SUBJECT: ON Semiconductor Product Bulletin #16176

TITLE: SNSS20200WP Product Update: SEMI to JEIDA Wafer Flat Conversion

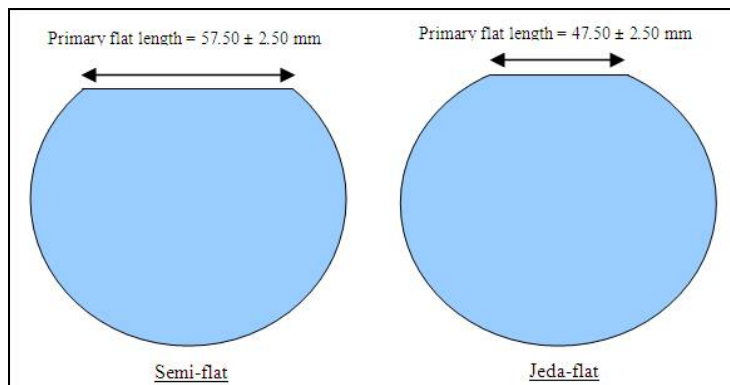
ON Semiconductor is notifying its customers, who purchase product in wafer form, of wafer flat conversion from SEMI to JEIDA flat. This is part of the initiative to standardize the usage of JEIDA-flat silicon material wafers across entire ON Semiconductor's internal wafer fabrication sites.

The difference between SEMI-flat and JEIDA-flat is through the primary flat length:

Semi primary flat length = 57.55 ± 2.5 mm

Jeida primary flat length = 47.50 ± 2.5 mm
